ESR Horsley Logistics Park Modification 4

Design, access and landscaping amendments to Lot 204,
and an updated signage masterplan
State Significant Development Modification Assessment
(SSD- 10436- Mod- 4)

May 2022

Figure 8 | Swept path diagram AG11 – 12.5 m HRV emergency vehicle

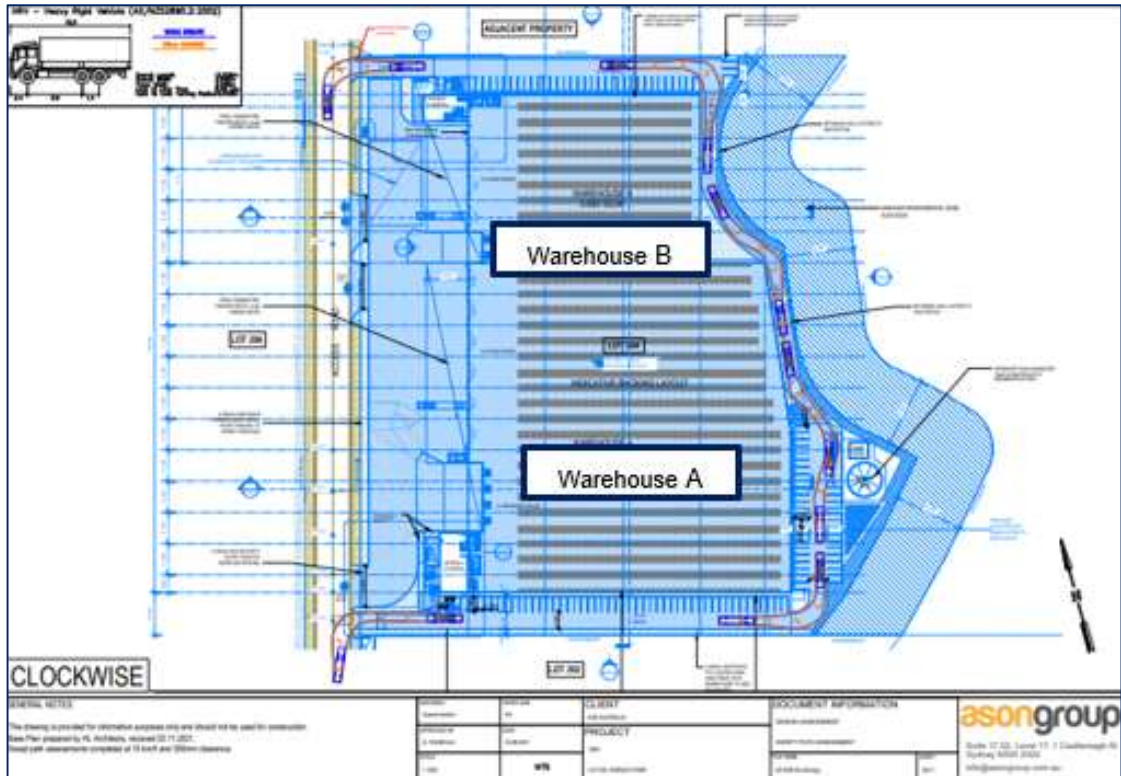
The Applicant provided swept path diagram AG11 detailing a 12.5m HRV fire truck entering the car park from the northernmost driveway and exiting from the southernmost driveway (**Figure 8**). The Applicant notes this swept path was prepared to demonstrate that during such emergency events, fire trucks can access the site and not cause on-site manoeuvrability issues. The Applicant notes that outside of emergency events, these driveways will only be utilised by light vehicles.

The Department acknowledges the concerns raised by Council regarding the manoeuvrability within the site and potential conflicts between vehicles at the northern and southern driveways within Lot 204.

The Department also notes that no changes are proposed to the approved access arrangements for emergency vehicles into and within the HLP. The Department agrees that the risk for potential vehicle conflict at the most northern and southern driveways of the site is low.
